**Assessment of Recent Soil Vapor
Investigations in the South Hill Area
of Ithaca, New York**

Prepared for:
NCR Corporation

Prepared by:
ARCADIS
6723 Towpath Road
P.O. Box 66
Syracuse
New York 13214-0066
Tel 315.446.9120
Fax 315.449.0017

Date:
February 2008

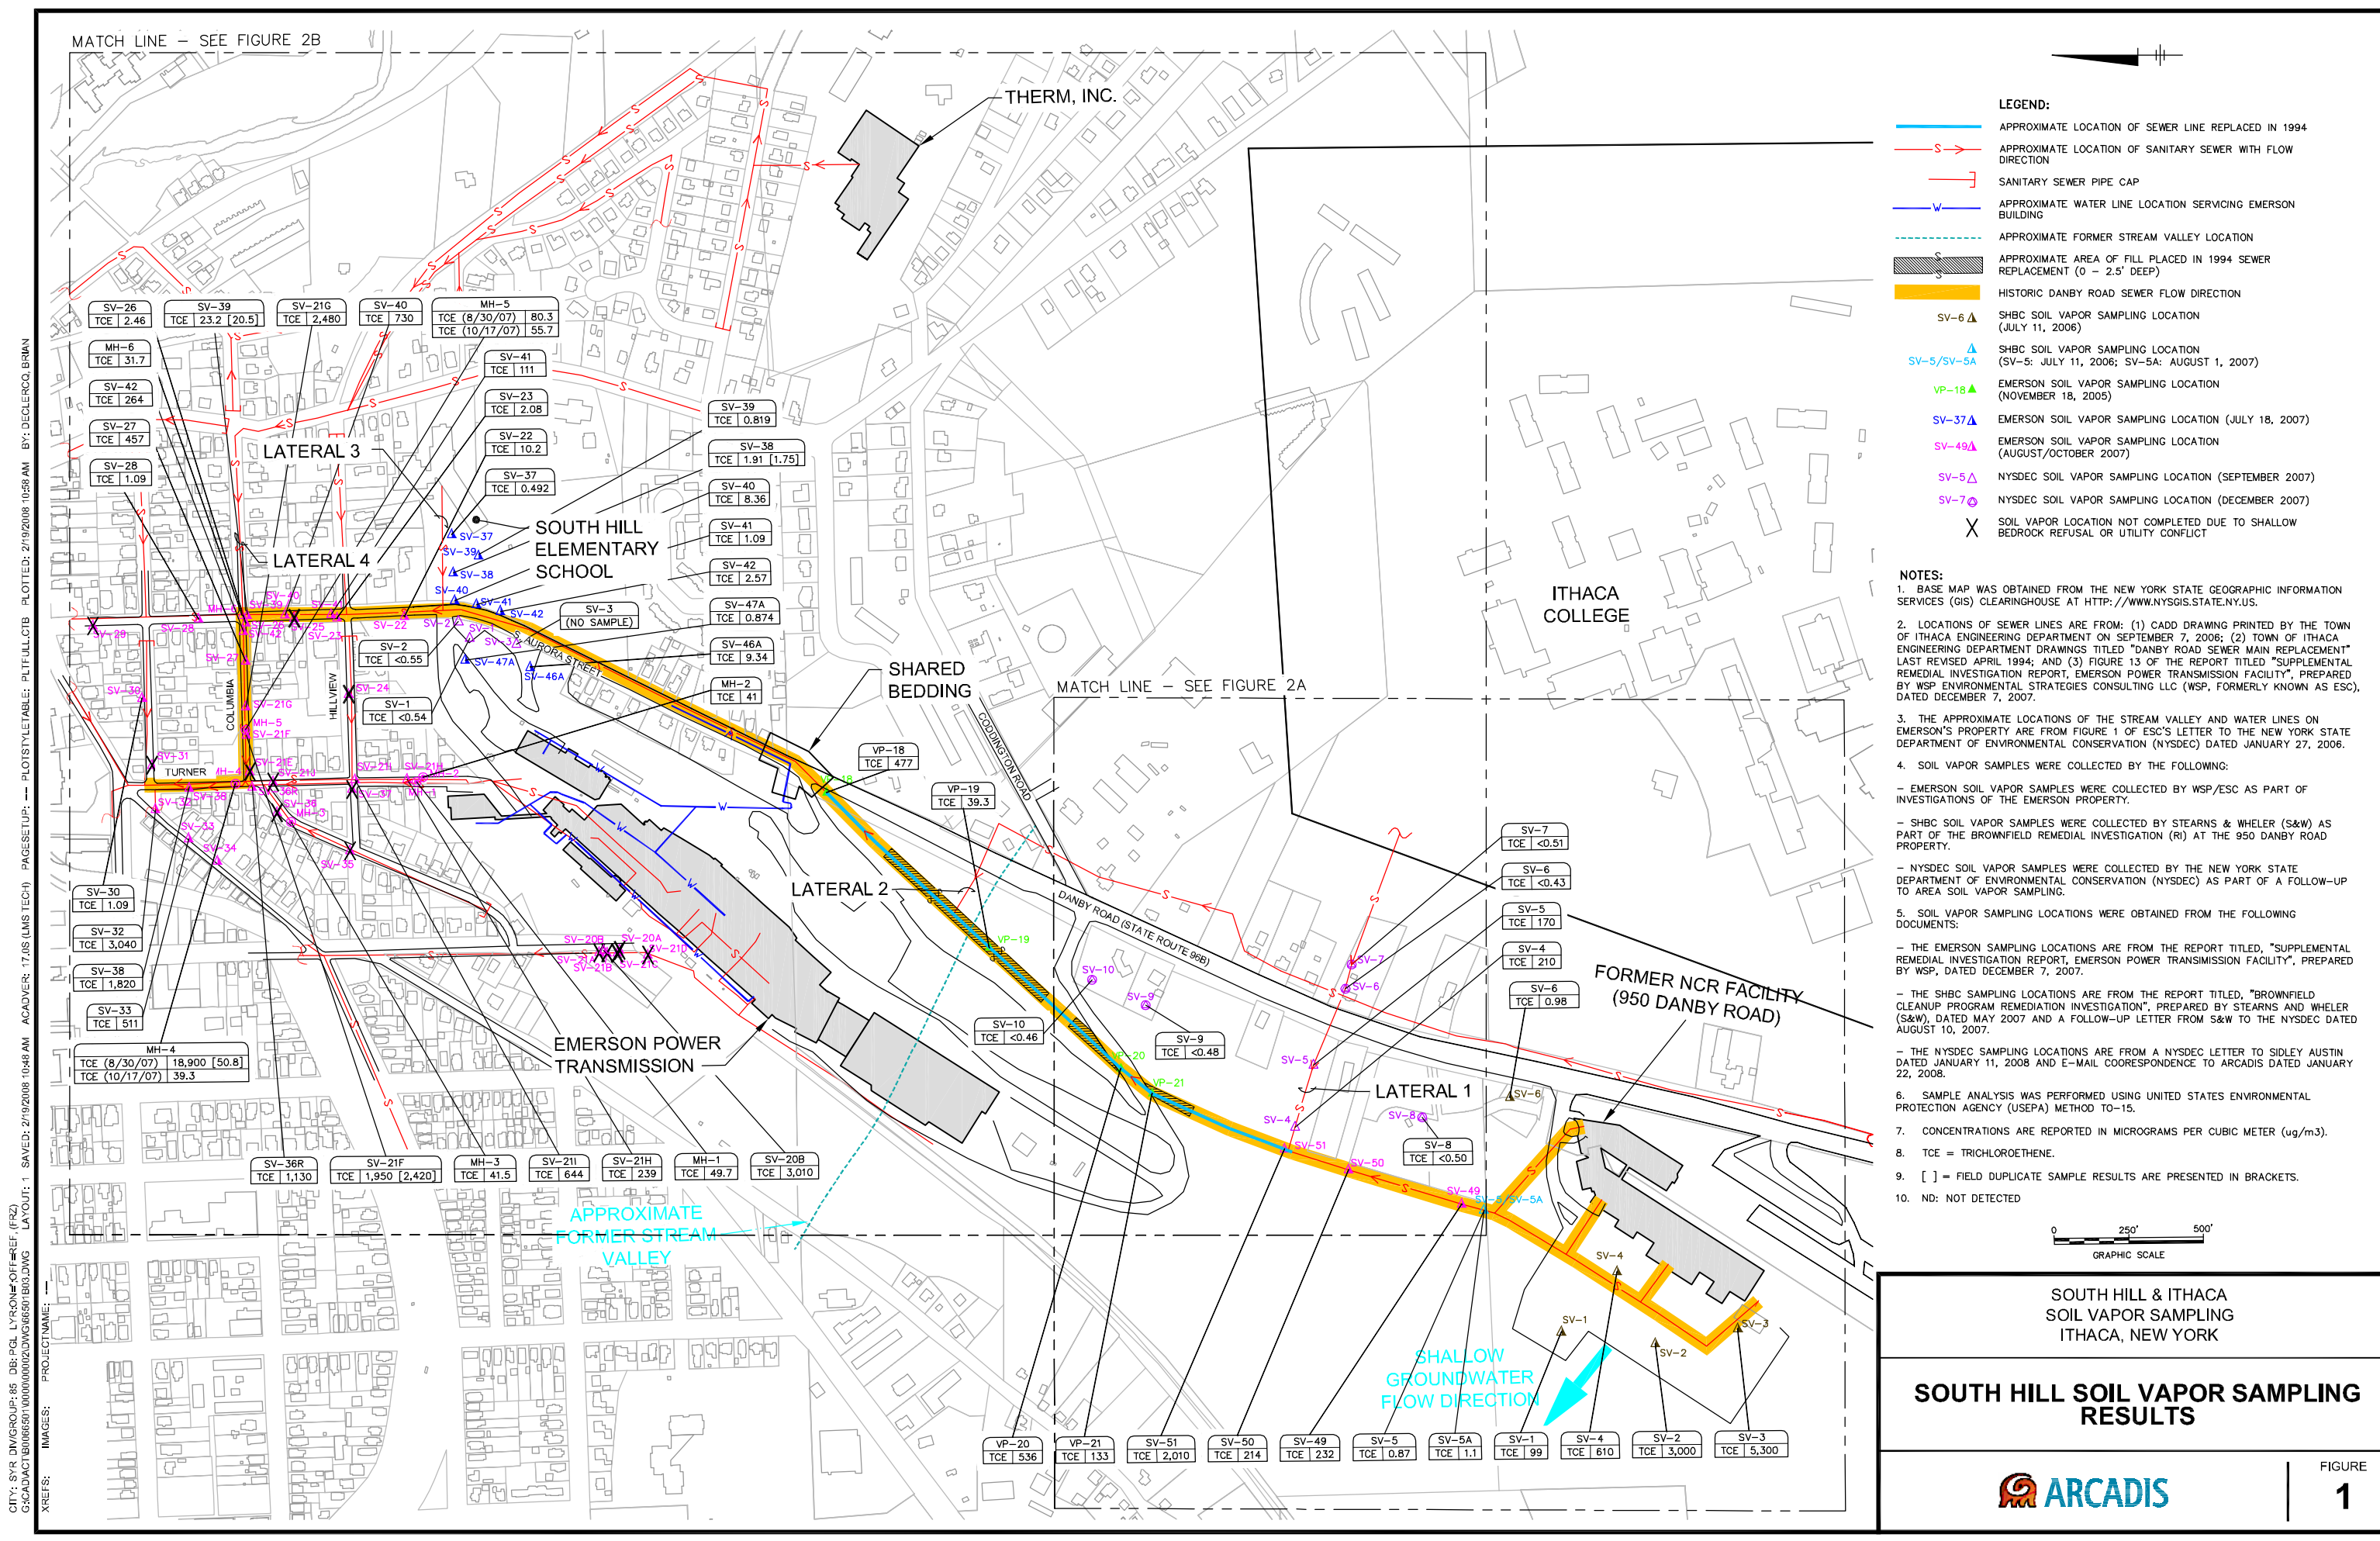
A depiction of 950 Danby Road, the adjacent Emerson facility, and the associated soil vapor sample results is included as Figure 1.

- Numerous Areas of Concern (AOCs) have been identified throughout the Emerson facility including several drum disposal areas. It is possible that subsurface contamination resulting from drum disposal areas, or other disposal areas, near the southern portion of the Emerson property are the source of elevated concentrations of TCE in soil vapor in the vicinity of soil vapor sample SV-51 near the Danby Sewer Line (see Figure 1).

Most notably, no soil or groundwater investigation has been conducted along the southern area of the Emerson site near SV-51 (see Figure 1) to evaluate the potential source of elevated TCE readings in soil vapor at that sampling point.

SOUTH HILL & ITHACA SOIL VAPOR SAMPLING ITHACA, NEW YORK	
SOUTH HILL SEWER NETWORK (SOUTH)	
	FIGURE 2A

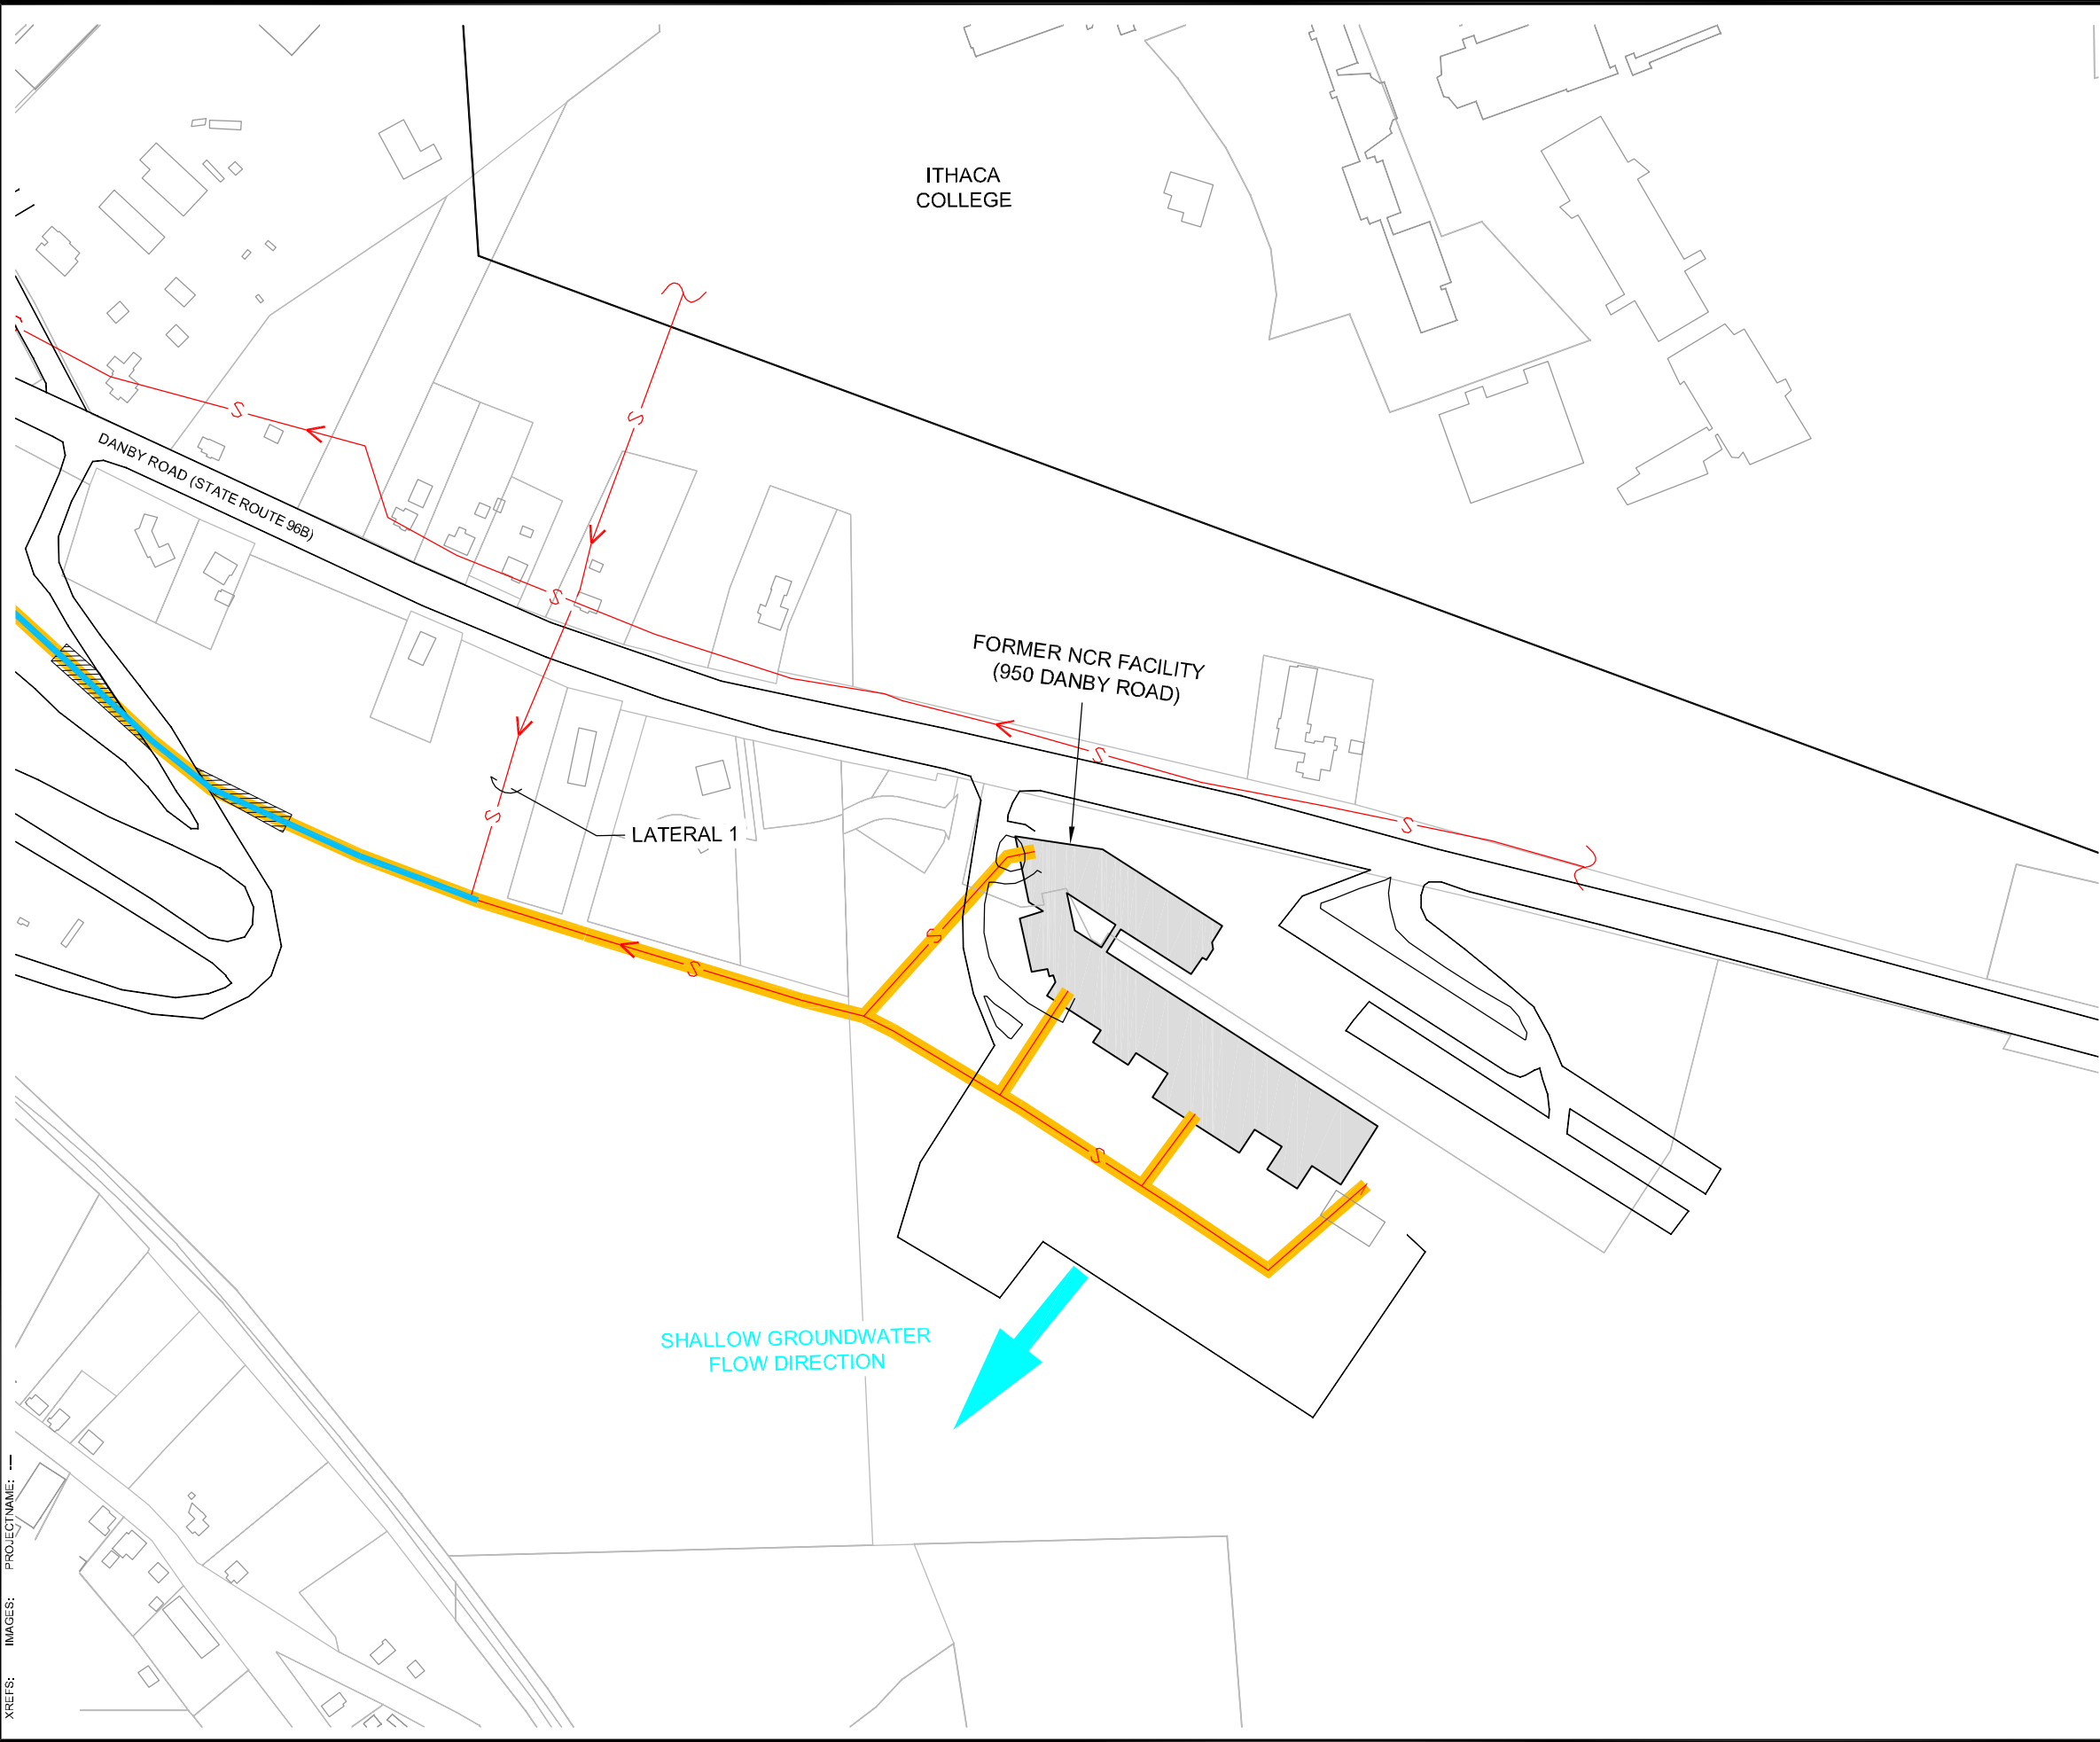
ARCADIS performed an evaluation of the South Hill sewer network relative to inferences made by the NYSDEC that alleged (and unsubstantiated) historic releases of TCE by NCR to the sanitary sewer system have resulted in possible vapor intrusion impacts at various locations north of 950 Danby Road. This evaluation included a review of drawings obtained from the City of Ithaca and Town of Ithaca Municipal Offices as well as discussions with Mr. Scott Gibson of the City of Ithaca Water and Sewer Department. The review targeted the sewer piping network in the area along Danby Road between 950 Danby Road and the Emerson facility and portions of the residential neighborhood to the north of Emerson. A general layout of the South Hill Area sewer network is presented on Figures 2A and 2B. Our findings following this review are summarized below:

ARCADIS' review of the Danby Sewer Line drawings identified an area on the northwest side of the Emerson property where the potable water supply shares bedding with the Danby Sewer Line. This instance of shared bedding presents a potential pathway for TCE-contaminated soil gas to migrate to the Danby Sewer Line bedding. No investigation has been performed of this potential migration pathway.
